A REPAIR A13070

ON-SITE SEWAGE DISPOSAL SYSTEM HOWARD COUNTY HEALTH DEPARTMENT BUREAU OF ENVIRONMENTAL HEALTH

SUBDIVISION: Woodmark III LOT NUMBER: 54, Block E

ADDRESS: 12220 Ioka Court PROPERTY OWNER: Timothy Siebes

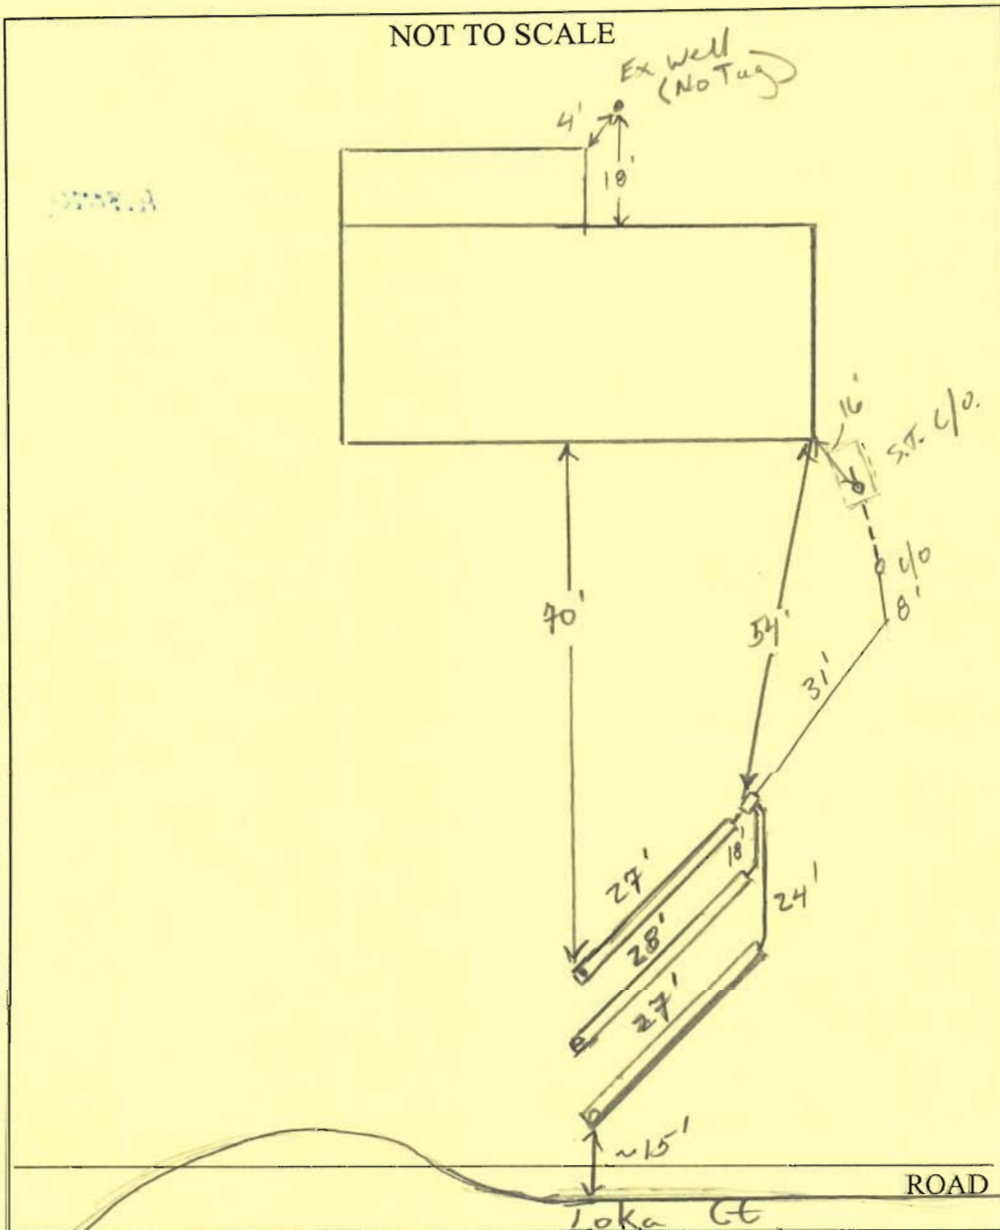
*Trenches 2' Wide
Inlet 4'
Bottom 10'
6' of Stone Below Pipe
3 - 27' Trenches or*

2-40' Trenches

6/7/07 Contractor could not make inlet depth of 5' due to invert of ex pipe from S.T. Inlet changed to 6'. Trench now to be 6'-10' w/ 3' wide. No trenches dug. (KW) 6/7/07 (pm) Top 2 trenches complete. Bottom trench almost complete. OK to back fill when finished. (KW)
